# Access Compliance Report

## Public Rights-of-Way

### (Curb Ramps)

Intersection ID: N/A	Main Street: ARBOR_LOOP_DR	Cross Street: N/A	Location: S
ADA ID: 5C1DE17260BC	Ramp Type: Directional1	Initial Pass/Fail: Fail	Overall Compliance: No
Codes/Mitigation Info/Possible Solution		Field Measurements/Component Compliance	
Severity Score: 12.5

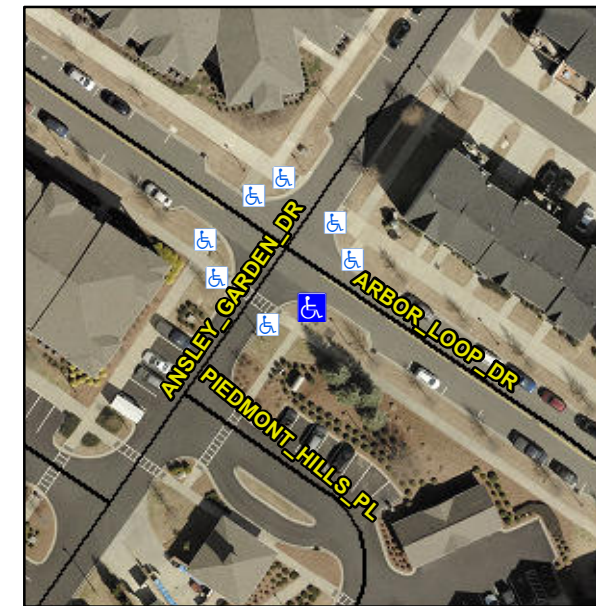
**R304.2.2**

Compliance	Description	Data	Compliance	Description	Data
N/A	Ramp Length (in)	75.0	N/A	Grade Break?	N/A
Yes	Ramp Width (in)	57.0	N/A	Grade Break Slope (%)	0.0
No	Ramp Slope (%)	9.0	N/A	Grade Break XSlope (%)	0.0
Yes	Ramp XSlope (%)	0.8			
N/A	Flare Type LT	N/A	N/A	Flare Type RT	N/A
N/A	Flare Slope LT (%)	N/A	N/A	Flare Slope RT (%)	0.0
N/A	Flare Traversable LT?	N/A	N/A	Flare Traversable RT?	N/A
N/A	Landing Length (in)	0.0	N/A	DWS Provided?	N/A
N/A	Landing Width (in)	0.0	N/A	DWS Contrast?	N/A
N/A	Landing Slope (%)	0.0	N/A	DWS Length (in)	N/A
N/A	Landing X Slope (%)	0.0	N/A	DWS Full Width?	N/A
N/A	Landing Curb? (Y/N)	N/A	N/A	DWS Offset LT (in)	N/A
N/A	Shared Landing?	N/A	N/A	DWS Offset RT (in)	N/A
N/A	Gutter Ponding?	0.0	N/A	Gutter Slope (%)	N/A
N/A	Gutter Lip Ht (in)	0.0	N/A	Gutter X Slope (%)	N/A
N/A	Painted X Walk1?	No		Road Slope (%)	1.8
	X Walk 1 Direction	To NE		Road X Slope (%)	1.9
	X Walk 1 Width (in)	N/A		Clear Space?	N/A

**Remove & Replace Entire Ramp.**
